Middlemore Hospital – Galbraith Building

Independent Structural Review

Prepared for Counties Manukau District Health Board

26 April 2018

Figure 3.1: Example of shear failure of a short column, caused by influence of adjacent partial height infill (Kam, 2011) (L) and illustration of a 'short column' (R).

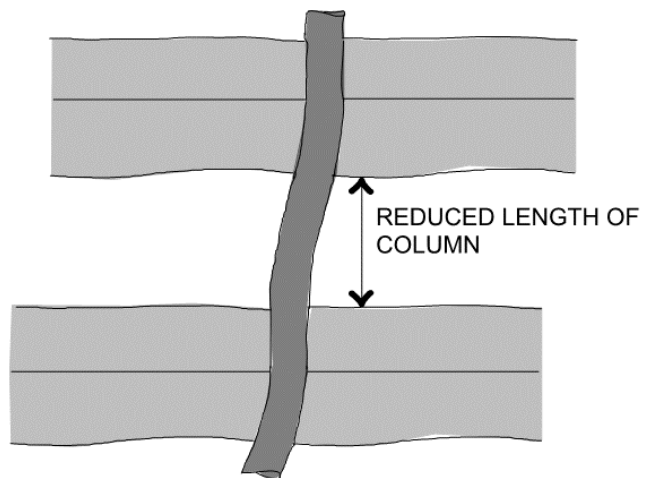
The primary frames score is limited by the performance of the tower structure, in particular the perimeter frames in both directions. The eastern and western elevation frames are limited by their flexural and shear strength from two influences the reinforced concrete partial height walls have on the frames. Firstly the concrete upstands increase the lateral stiffness of the perimeter frames, which cause them to resist proportionately more load than the internal frames. The second impact is the 'shortening' of the columns. The concrete upstand reduces the effective length of the column, meaning that any hinges must form between the clear length of the beam above, and the upstand below. This significantly increases the shear demand on the column, leading to a premature shear failure of the column. The primary longitudinal frame has thus been scored 25%NBS (IL4) based on the performance of these columns.

Fig.3.2.1 Stair Details - Galbraith Block Stage 2 Building

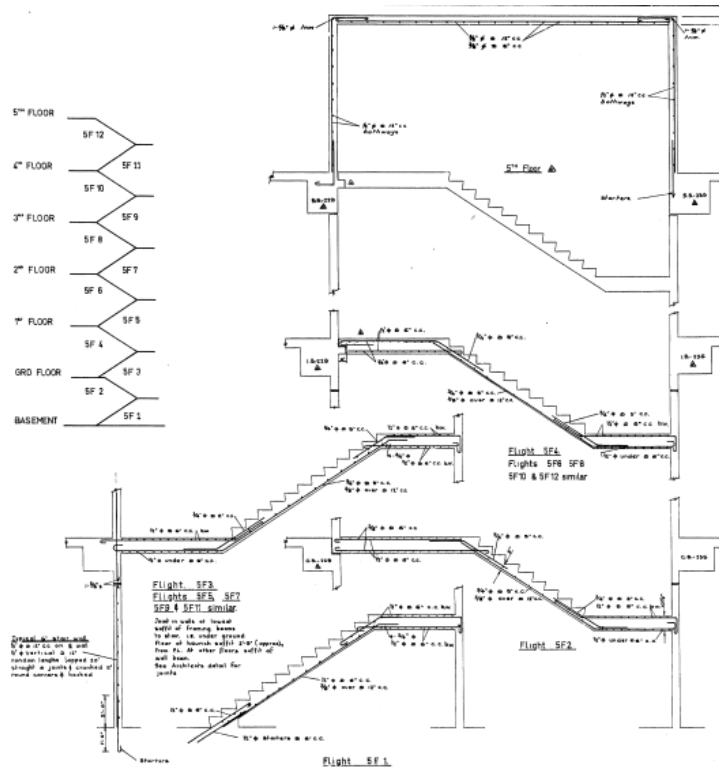
Because the stair cases are built in with no sliding connection, it is likely that stairs won't be able to accommodate the building displacement during the shaking leading to damage to concrete stairs, walls and potential loss of support of stair flights at each floor level.

Fig. 4.5.1 Galbraith – Bray Link

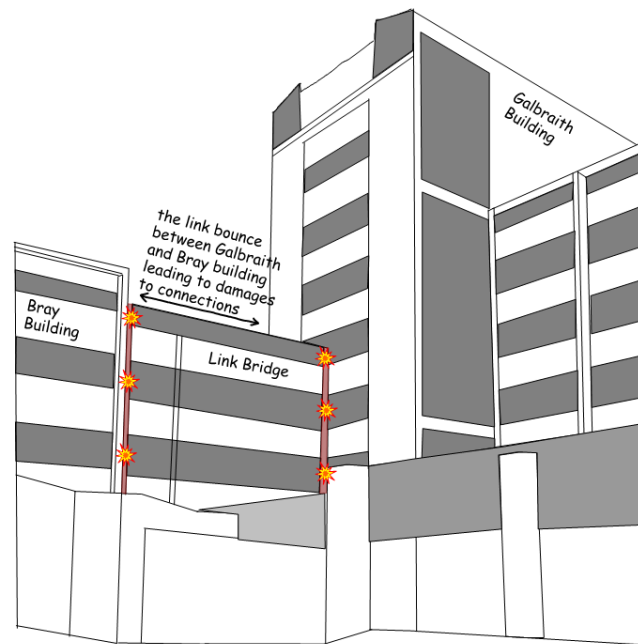
Our site visit and review of the available drawings lead us to find the link structure does not include a clearly identifiable defined lateral load resting system and a robust load path in the longitudinal direction. Our discussions with Holmes Consulting confirm this finding. During earthquake shaking the link structure will displace longitudinally and may well "bounce" between the floors of Galbraith building and Bray building.

It is possible that this 'bouncing' would lead to damage to the supporting connections. Of particular concern is the risk of damage to the bolt connecting the link bridge to the Galbraith Building. Should that bolt shear, there is a risk of loss of support at the Galbraith end of the link.

Fig. 4.5.1 Connection Details – Link Structure to Galbraith Building

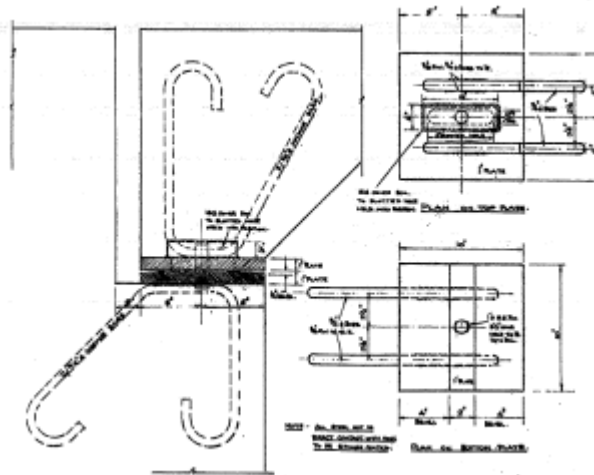
In our view, it is difficult to assess and quantify a reliable %NBS in the absence of a clear lateral load resisting system. While the 'bouncing' between Galbraith and Bray may well contain the link bridge, this is not a reliable load path.

Fig.4.5.1 Link Structure Section

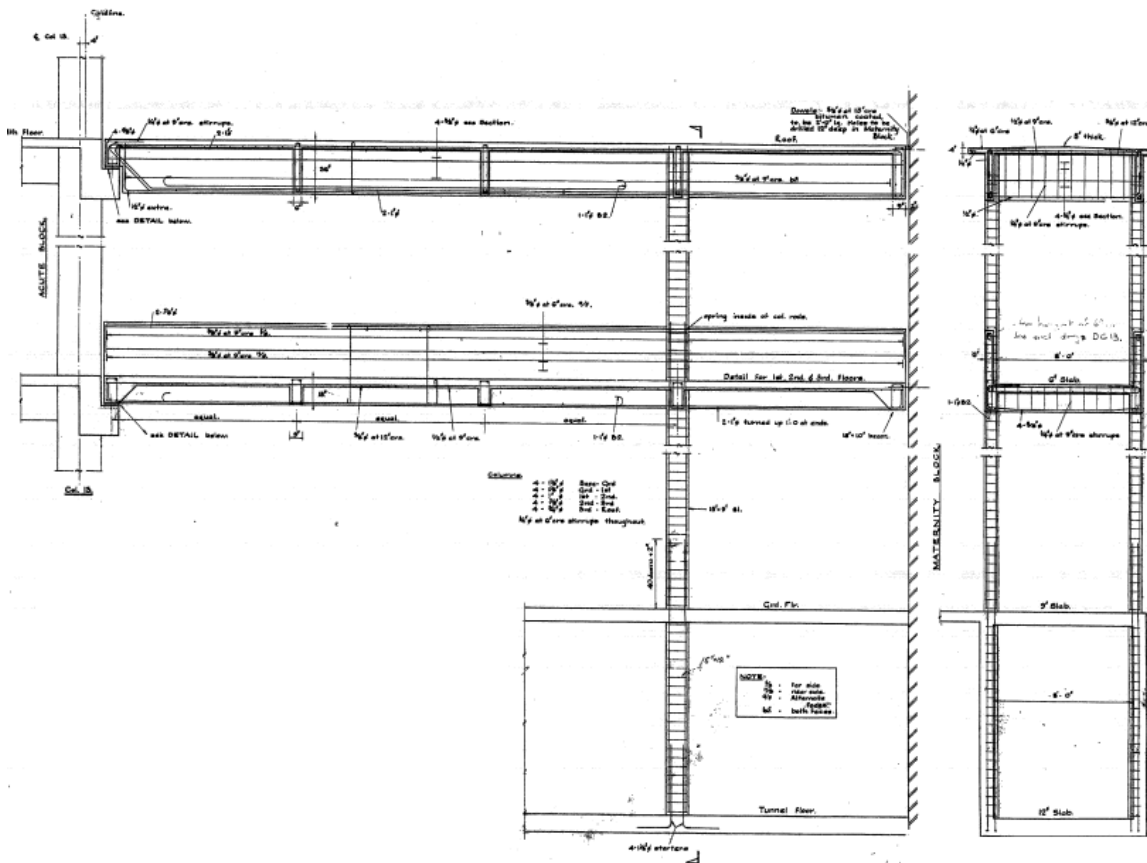
The lateral load resisting system in transverse direction comprises a slender reinforced concrete frame as shown below. Beca has undertaken an independent assessment of the frame which has resulted in 25%NBS (IL4) in the transverse direction. The seismic response of the link structure in these directions is governed by ground floor column flexural failure, leading to large storey displacements and eventual loss of gravity support.

Holmes Consulting has quantified the rating of the transverse frame as 30%NBS (IL4).

GROUND LEVEL AT
NORTHERN ENTRANCE.
SOIL RESTRAINT
PRODUCING A SHORT
COLUMN IN THE
LONGITUDINAL DIRECTION

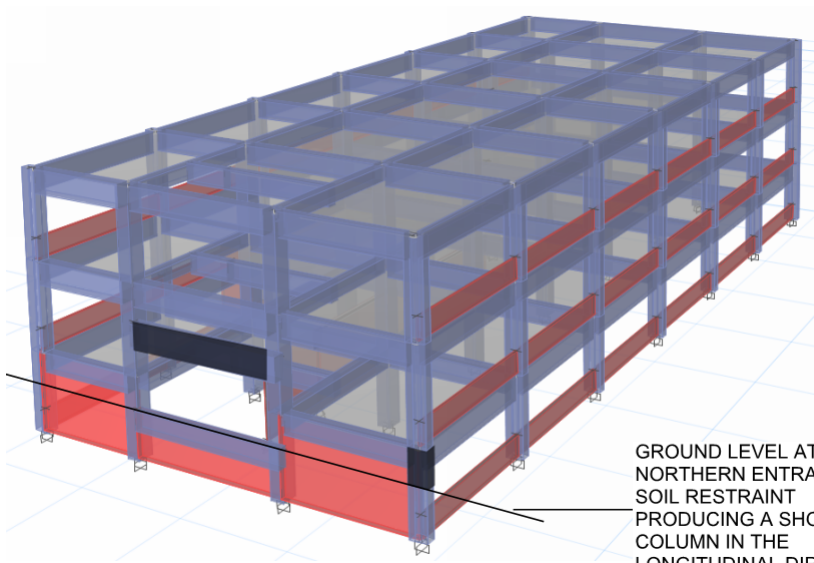
The Holmes report does not specifically mention any impact from the possible short column effects on the north end of the building. The analysis model does not appear to account for the structural configuration or boundary conditions at this end.

This is not expected to change the overall score of the structure, however the implications from the as-built geometry and the boundary conditions should be checked for any strengthening works undertaken for the building to ensure undesirable mechanisms are not occurring.
